CITY OF MOUNTAIN VIEW
RESOLUTION NO.
SERIES 2014

A RESOLUTION AMENDING THE SAN ANTONIO STATION
PRECISE PLAN TO REMOVE THE PROPERTIES REZONED
AS PART OF THE SAN ANTONIO PRECISE PLAN

THE SAN ANTONIO STATION PRECISE PLAN
(P8)

SAN ANTONIO STATION PRECISE PLAN AREAS
 * AREA B, FORMERLY AREA D (prior to 2014 amendments)

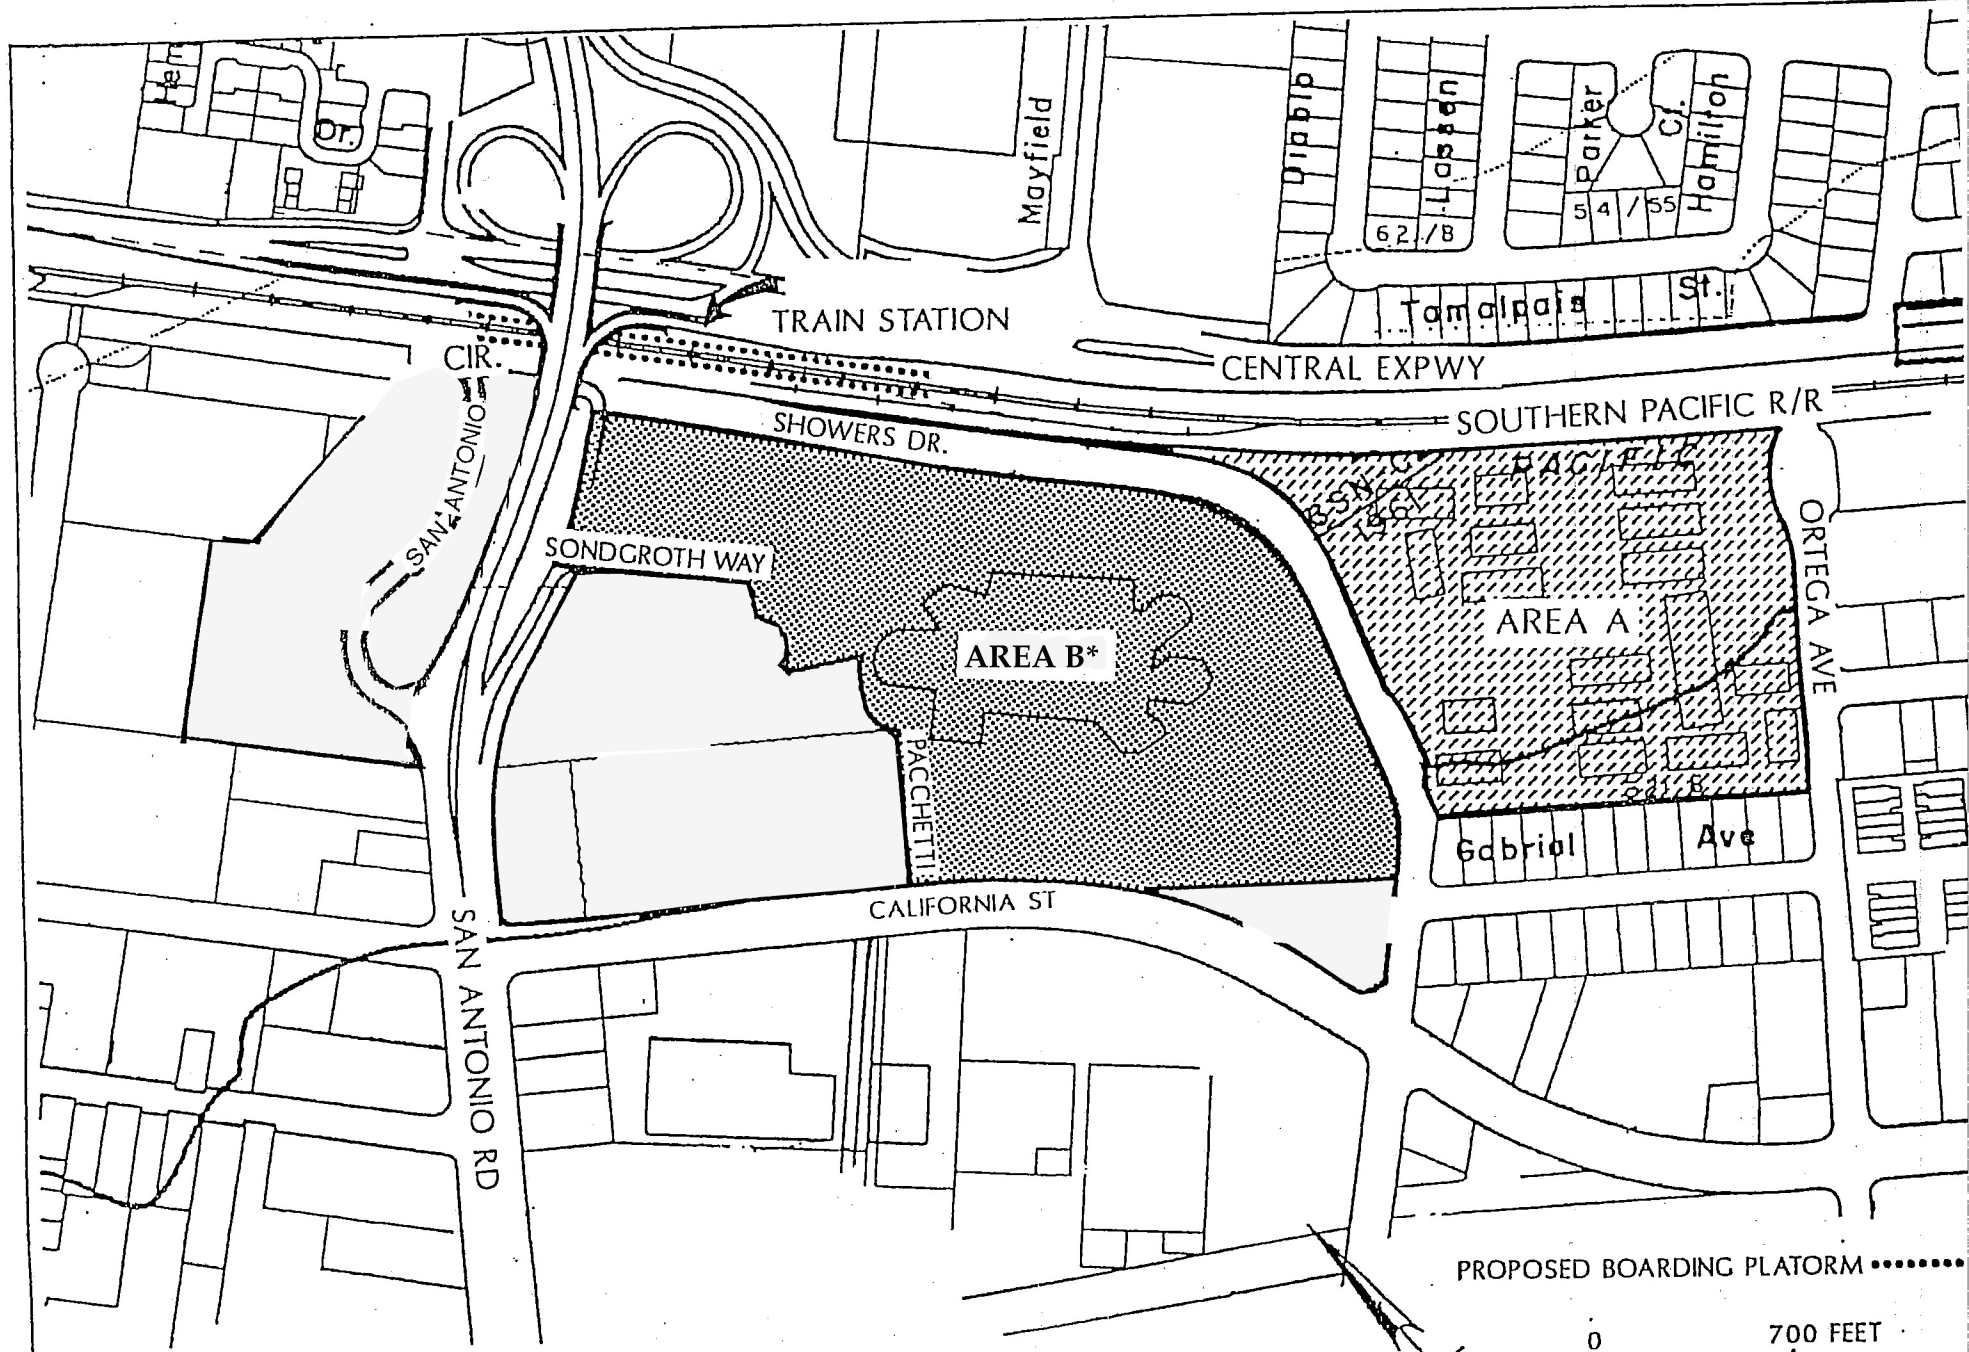
<u>AMENDED</u>	<u>RESOLUTION NO.</u>	<u>SUMMARY</u>
APRIL 25, 1995	15829	Changes promoting child-care facilities.
NOVEMBER 14, 1995	15890	Changes affecting required density, commercial building space, project phasing and parking, and creating a new Area E planning zone.
JUNE 25, 1996	15978	Changes in land use designation for Area E from High-Density Residential to Neighborhood Commercial and establish commercial development standards.
JUNE 29, 1999	16376	Uses and development criteria for Area C.
MARCH 26, 2002	16689	Amendments to height and setbacks in Area C.
		<u>Remove Areas B, C and E for inclusion in P(40); rename Area D to Area B.</u>

This Precise Plan covers the area generally bounded by a portion of San Antonio Road and California Street, Central Expressway, Ortega Avenue and the Showers Drive loop to San Antonio Road (Exhibit I). The area was substantially developed under the San Antonio-California Area Precise Plan adopted on May 8, 1972. This Plan was replaced by the Old Mill Area Precise Plan which was approved on January 29, 1985. A portion of the prior Plan area was incorporated into the San Antonio Precise Plan in December 2014. The size of the entire area is approximately ~~38.3~~27 acres. This Precise Plan area is divided into ~~four~~two zones:

- ~~Area D~~Area B – An 18.0-acre site generally bounded by California Street, Central Expressway, Showers Drive, Pacchetti Way and the Old Mill office building site. The Old Mill Specialty Center is currently located in ~~Area D~~Area B but is proposed to be redeveloped. ~~Area D~~Area B will be devoted primarily to housing, with a central area committed to mixed-use residential. ~~Area D~~Area B will also contain specialty retail service buildings and a CalTrain transit station.
